2018 BOND PROGRAM HARRISBURG SCHOOL DISTRICT #7

LIFE SAFETY PLAN - HS

AS-BUILTS

PROJECT #	DATE
18015	08/30/2019

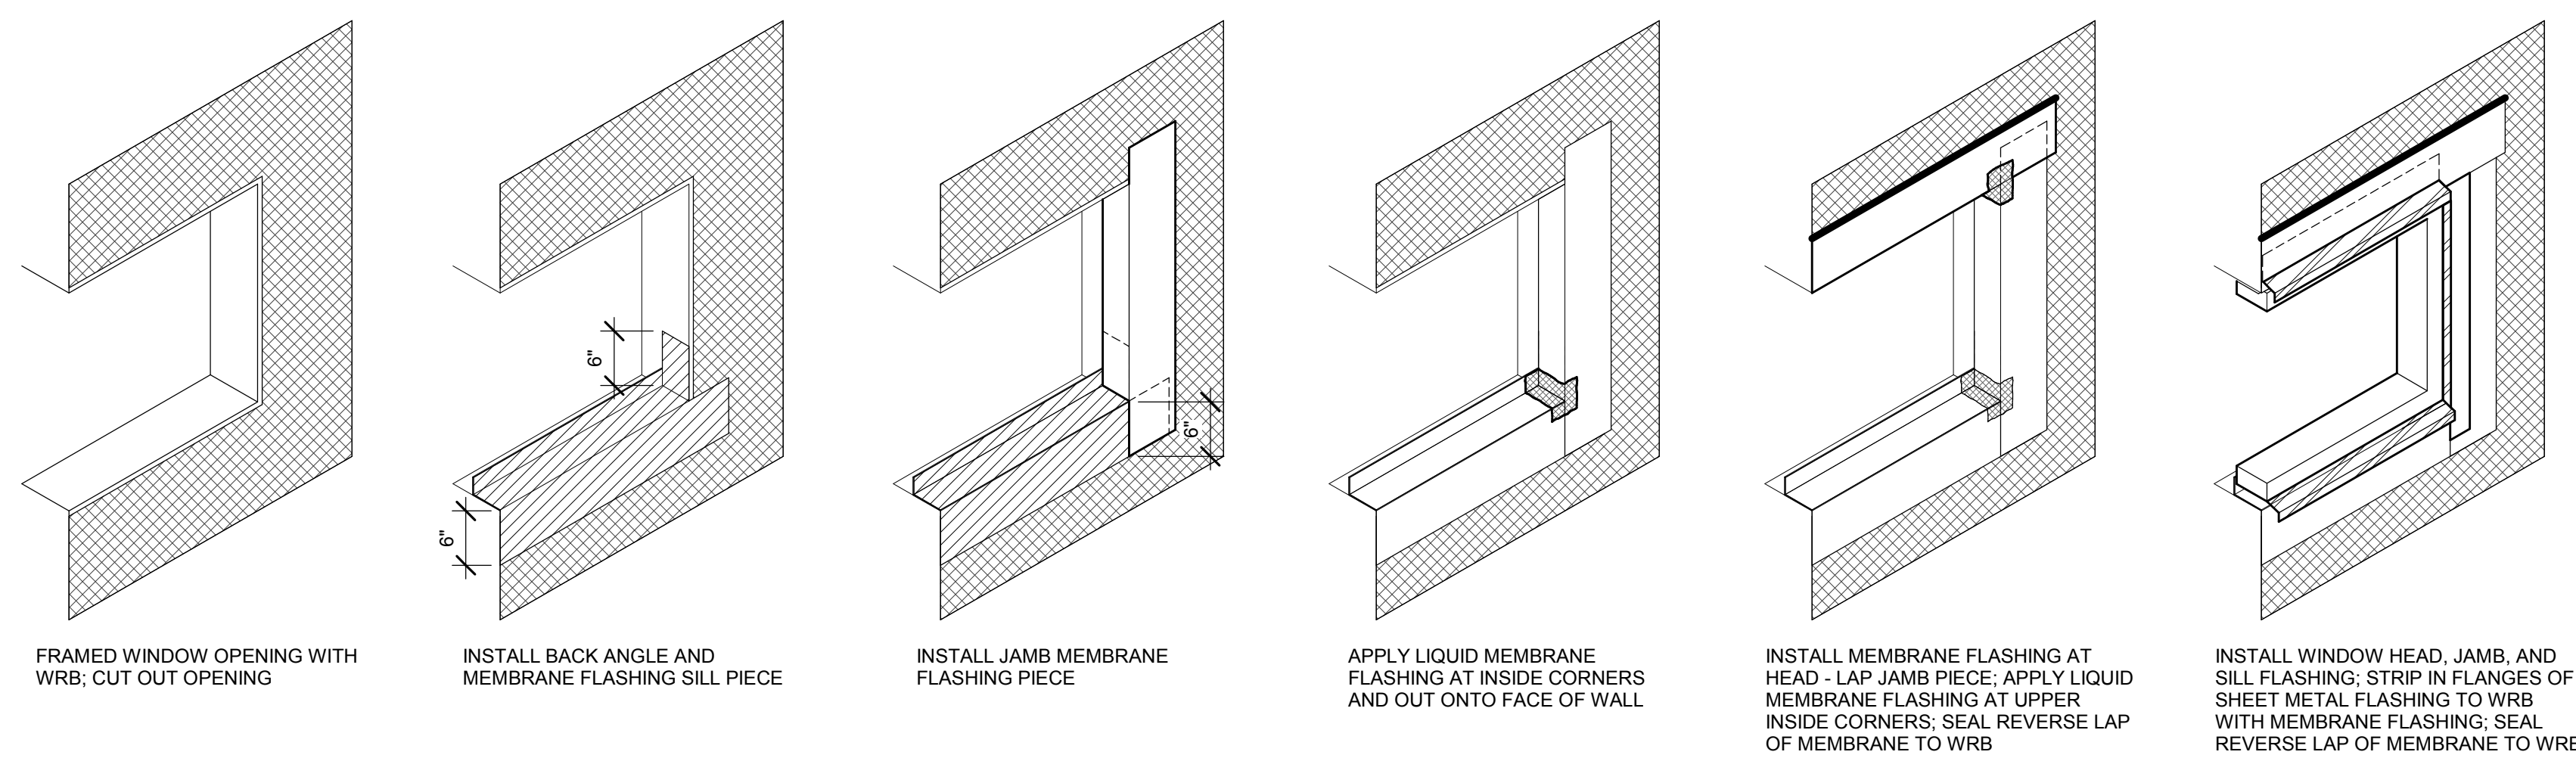
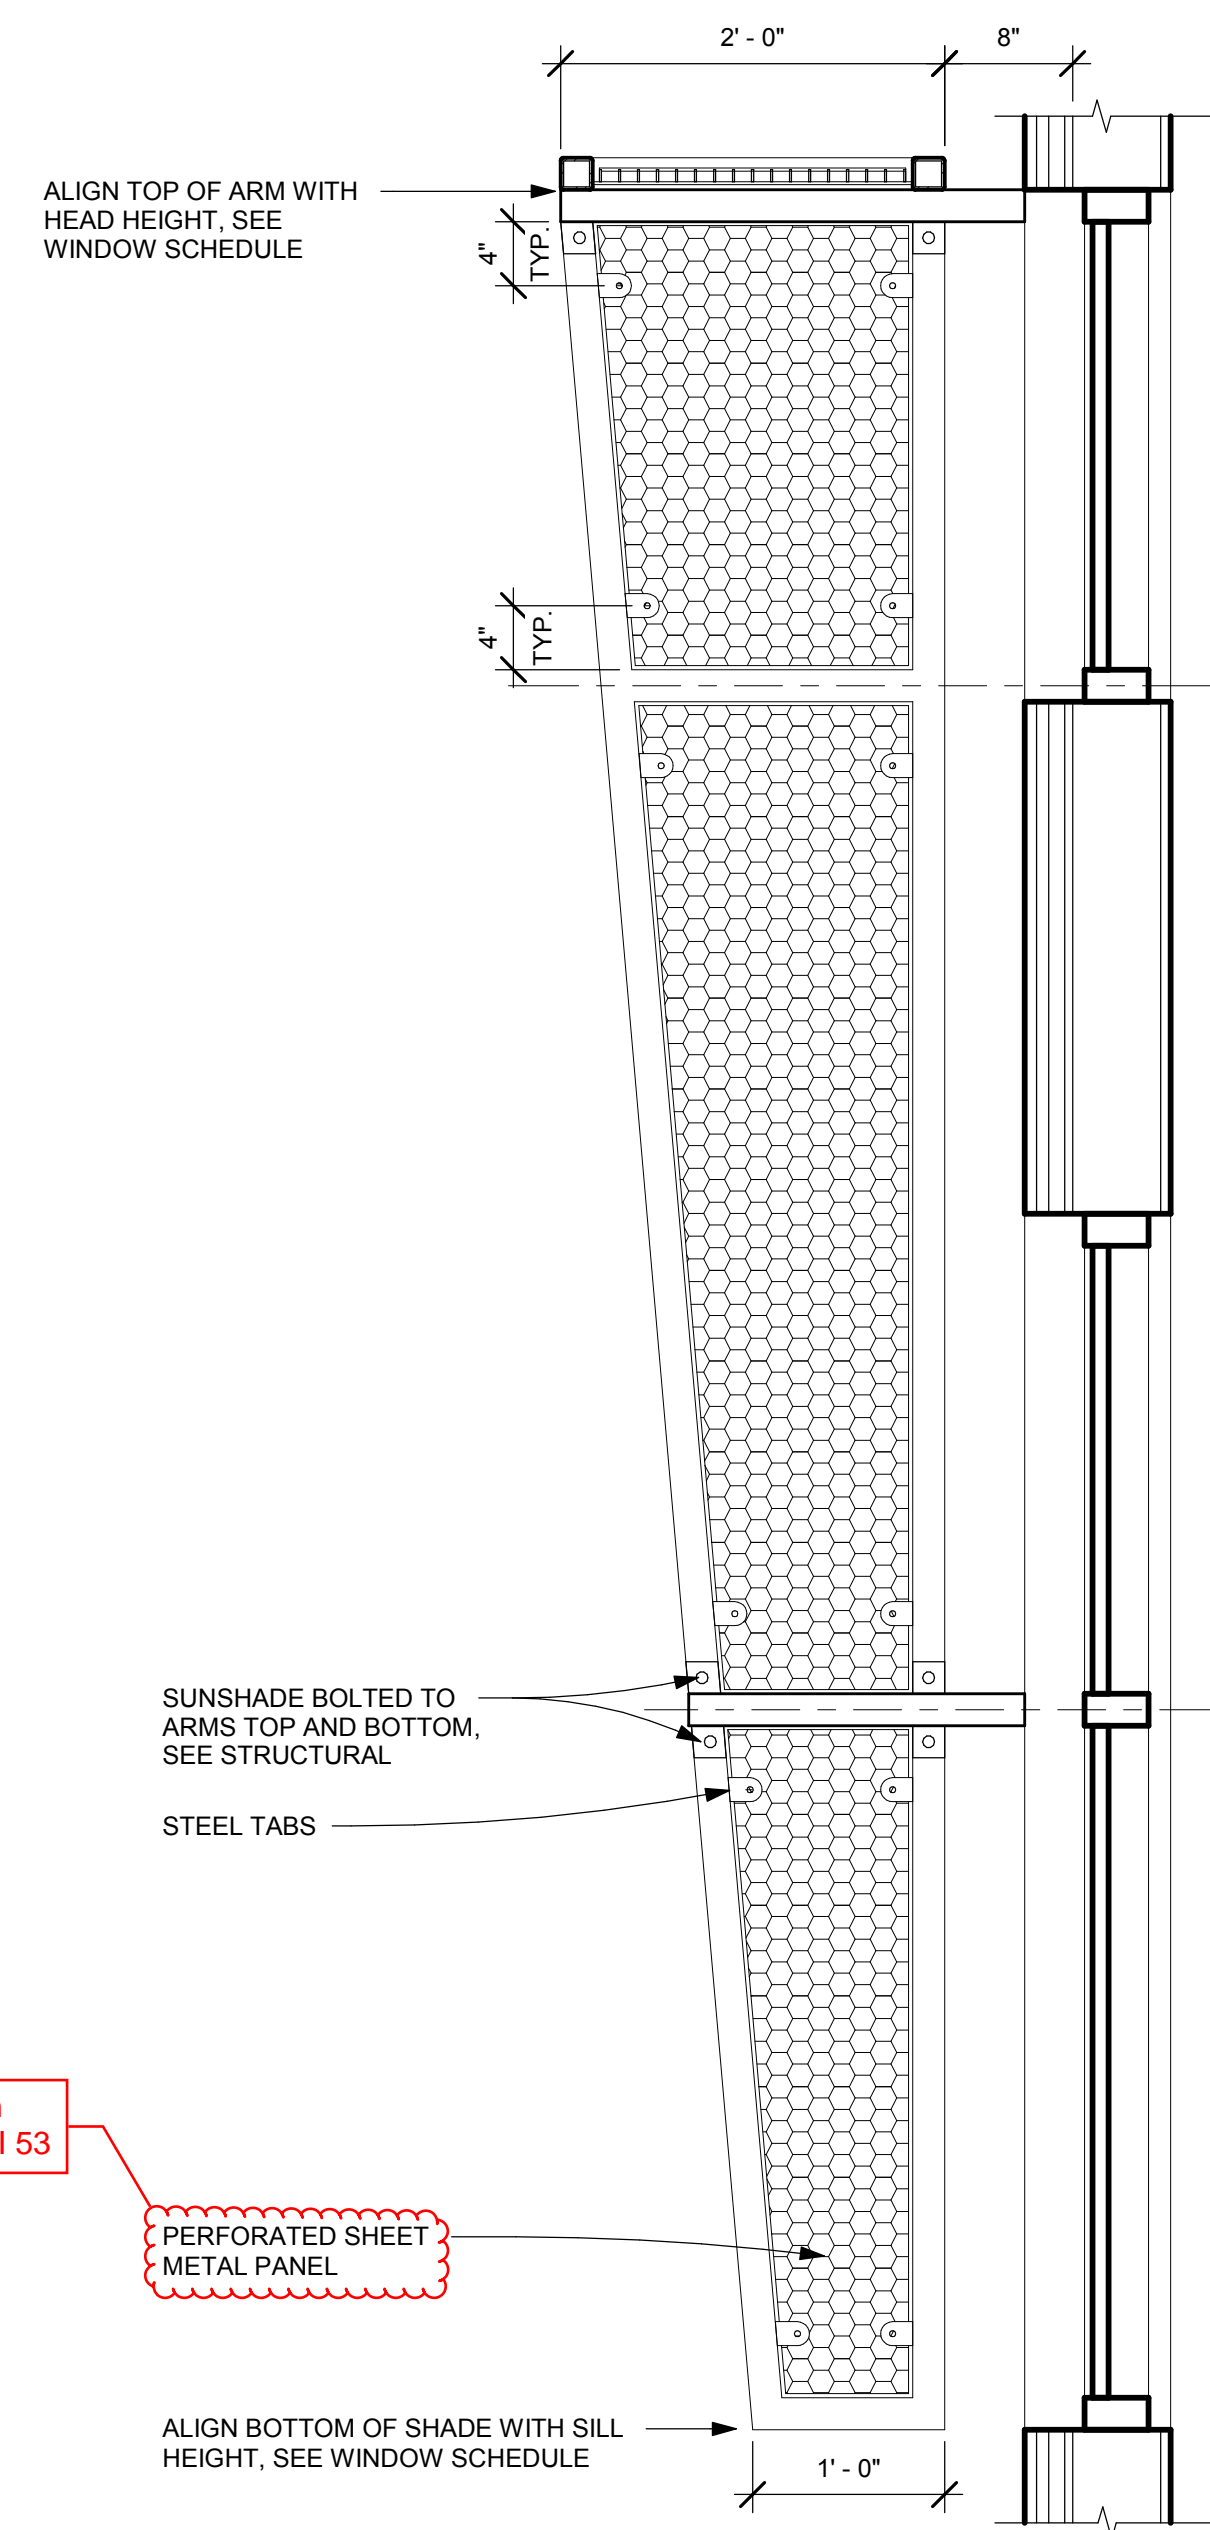
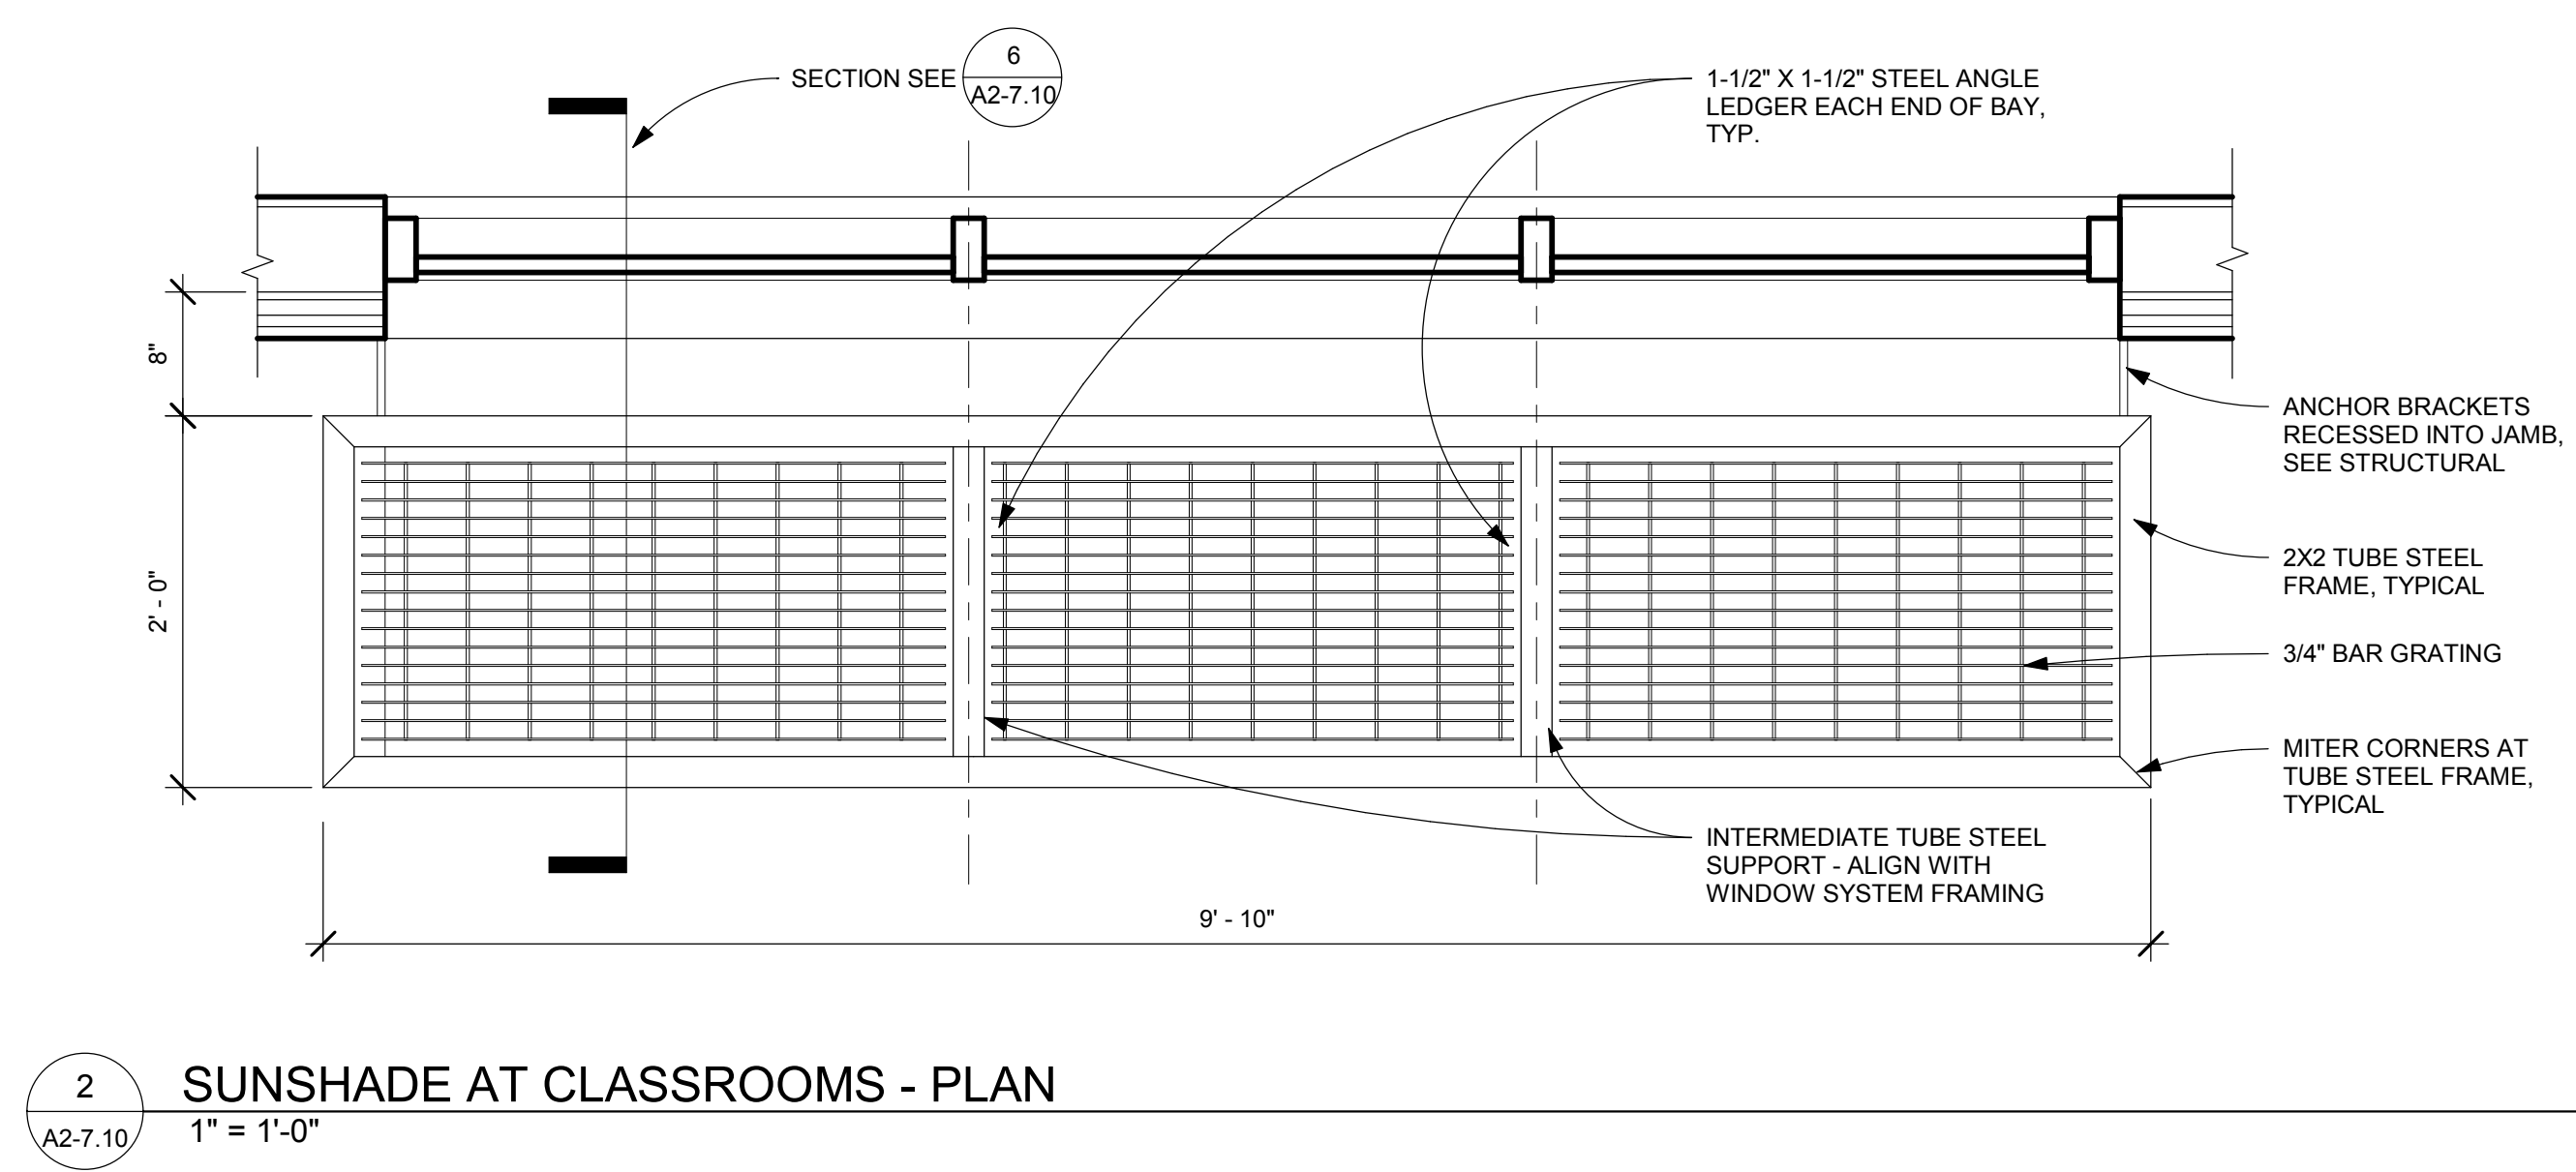
Revised Sunshade Bracket
See RFI 44 for additional flashing details
